Building Design Presentation for 922 Main Street

922 MAIN ST OREGON CITY, OR 97045

Proposed Revisions & updated drawings in response to Pre-Application Conference Notes from meeting on 3/29/2016.

ELEVATIONS	
Project number	16-001
Date	5-10-16
Drawn by	CHAD ECKELMAN
Checked by	GARY ECKELMAN
A4.0	
Scale	1/8" = 1'-0"

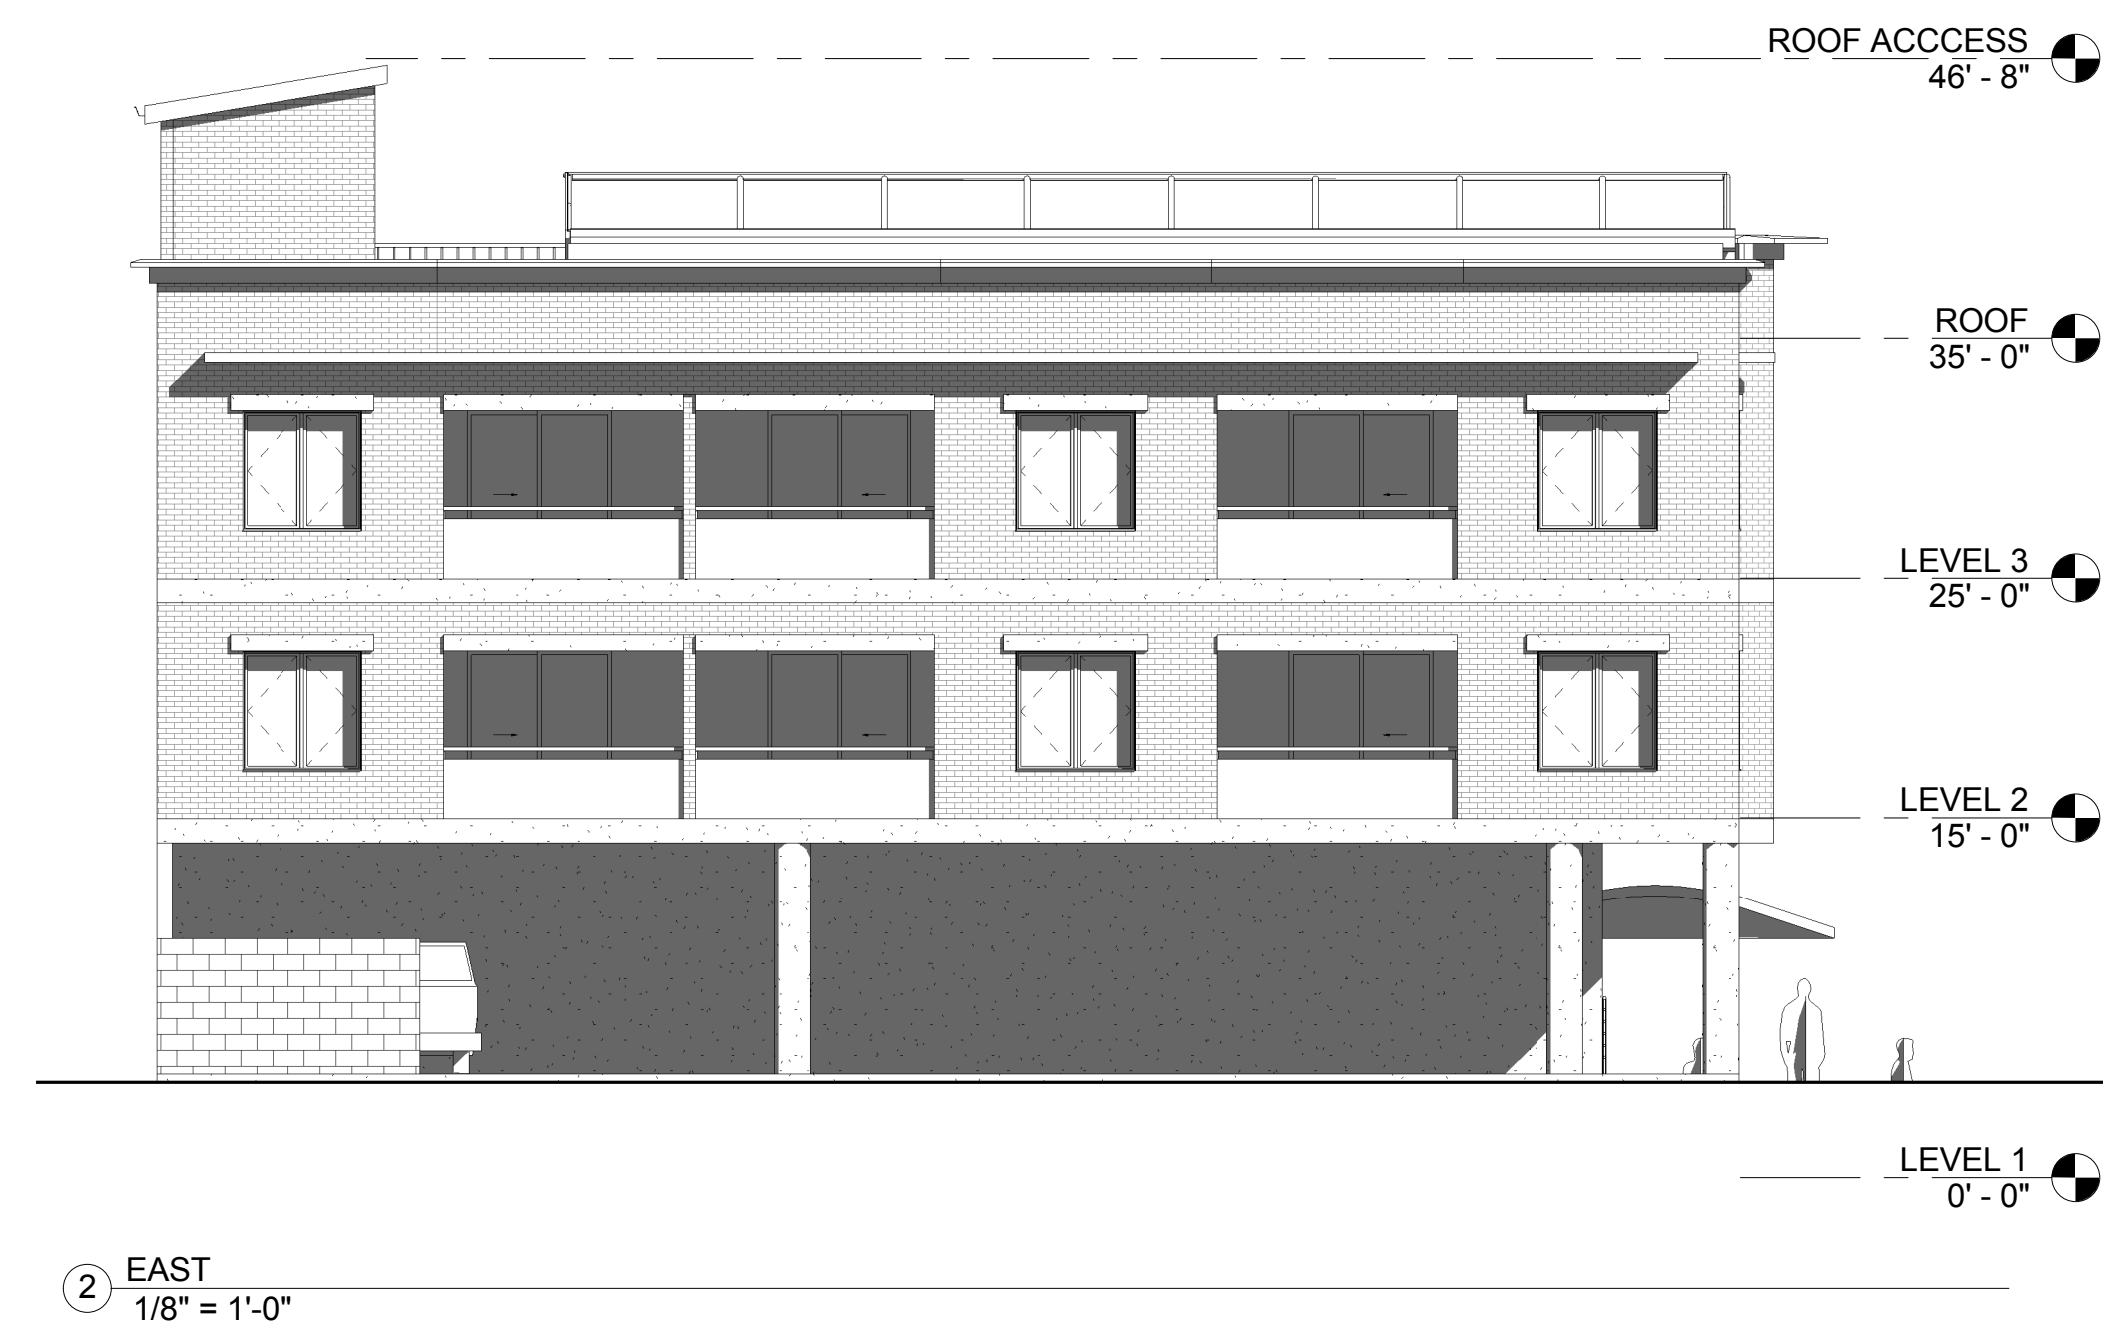
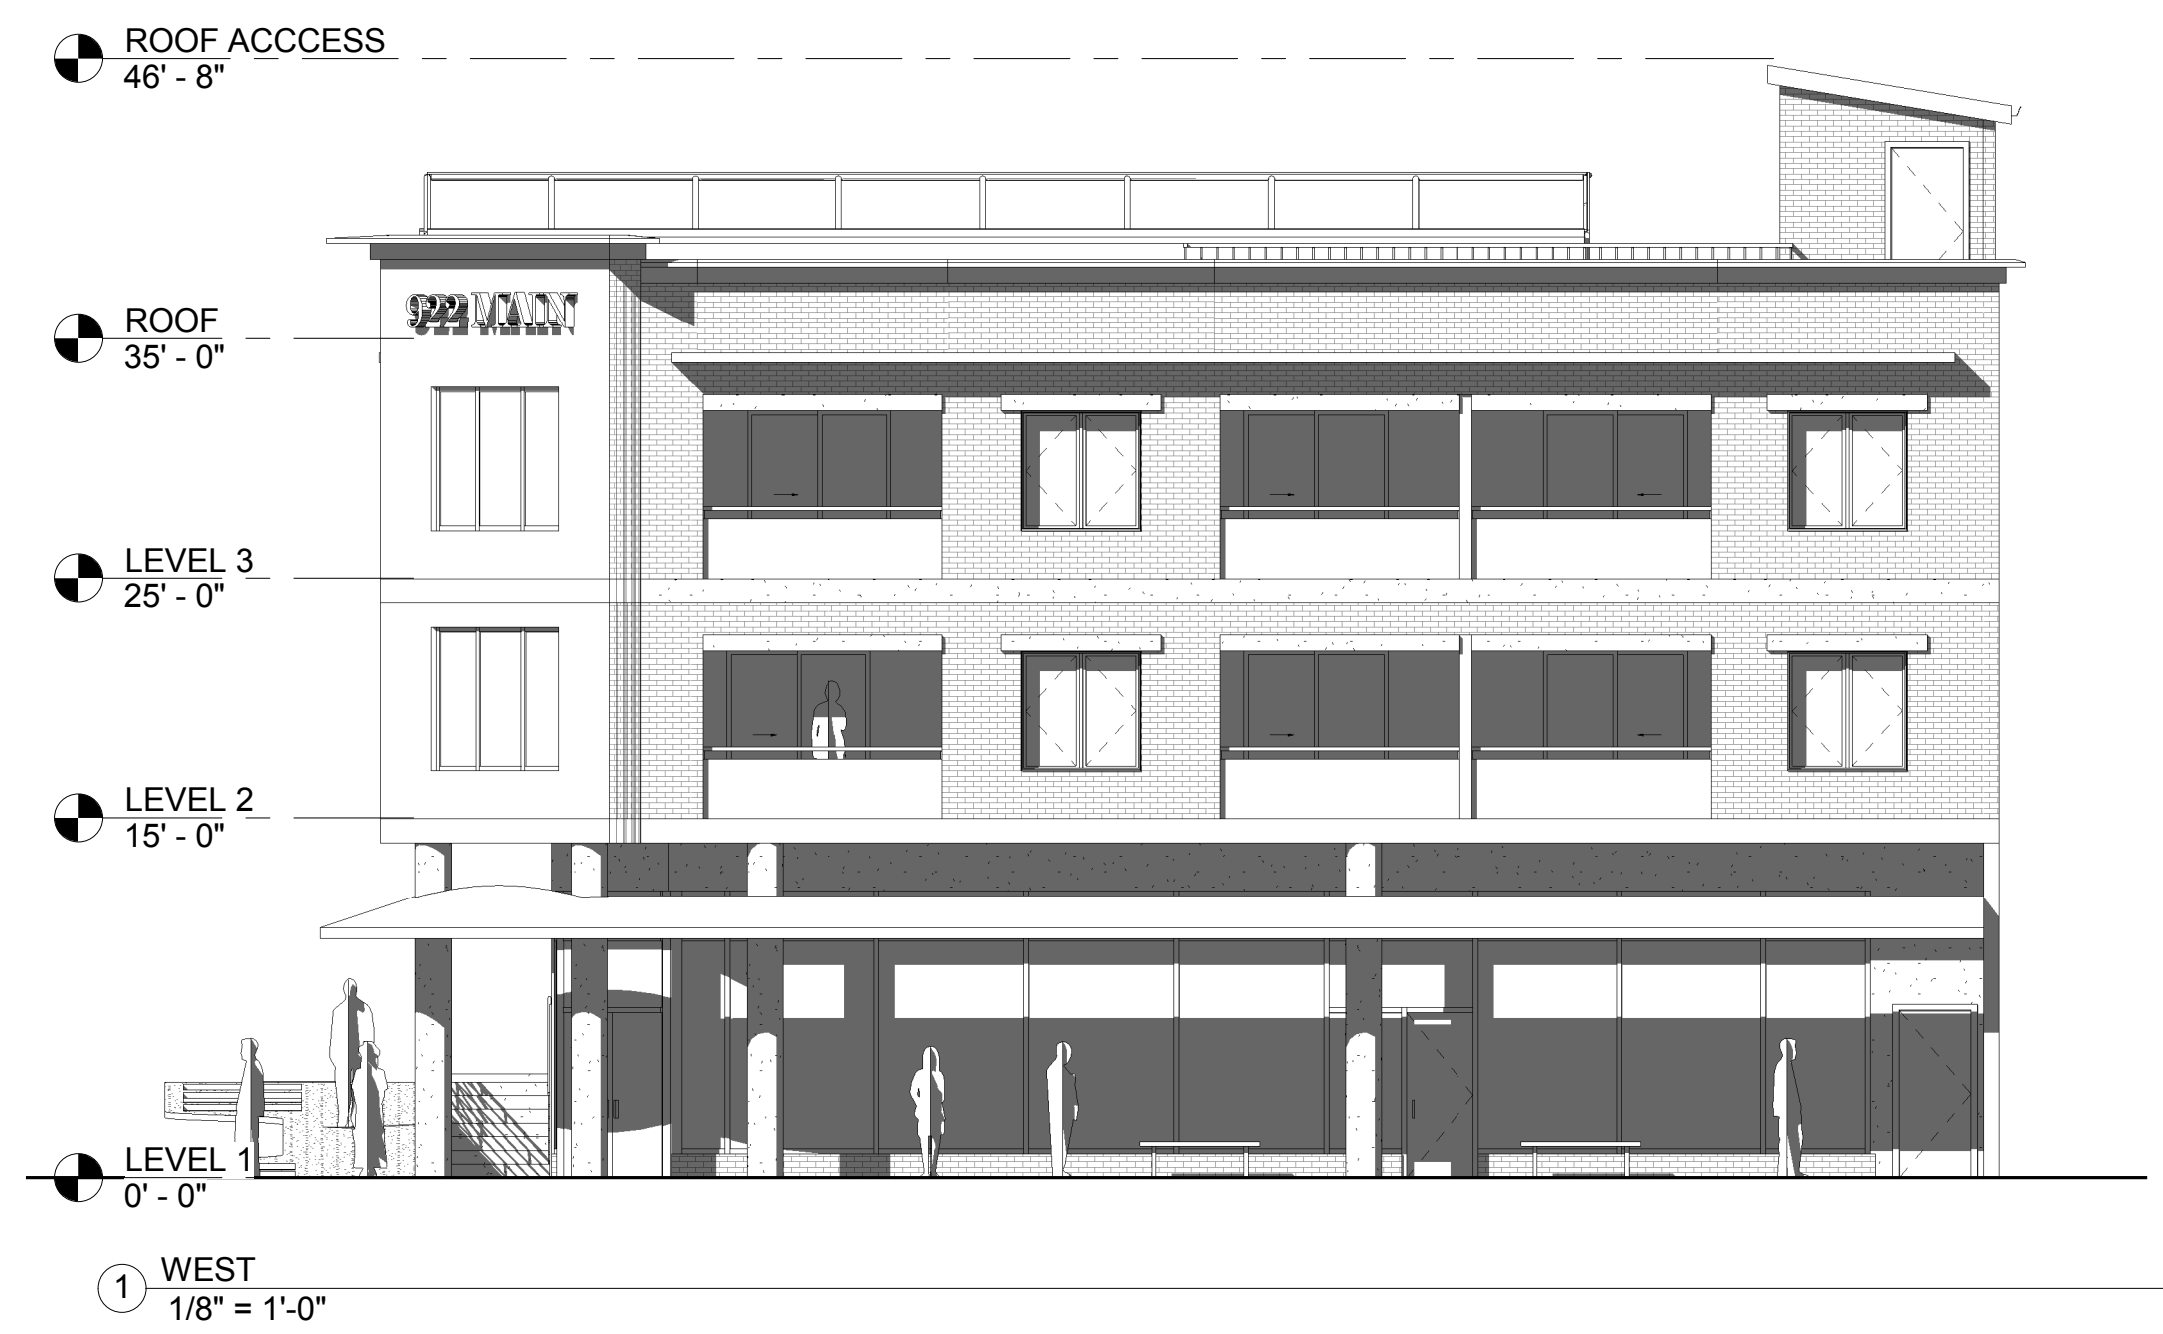
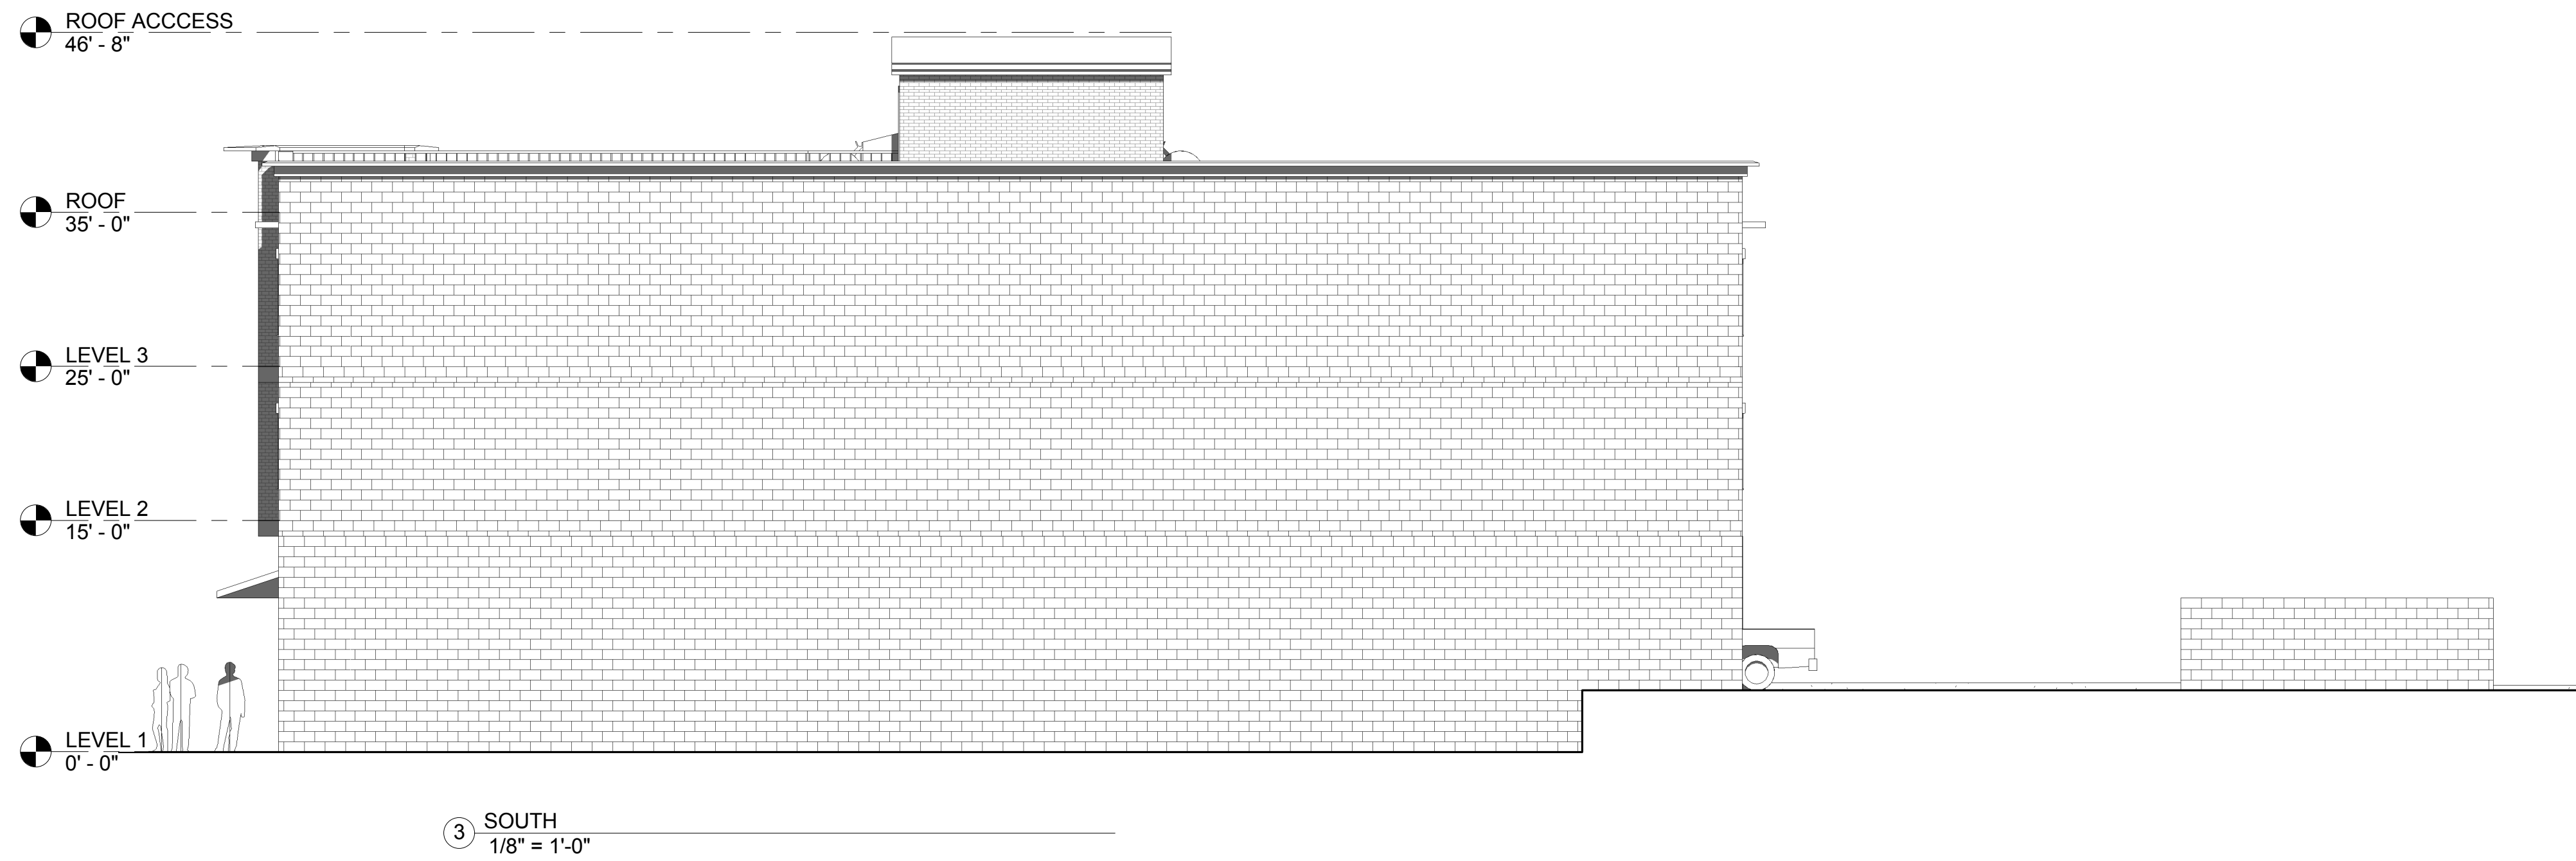
Compliance with Building Façade Standards

Please see revised building facades.
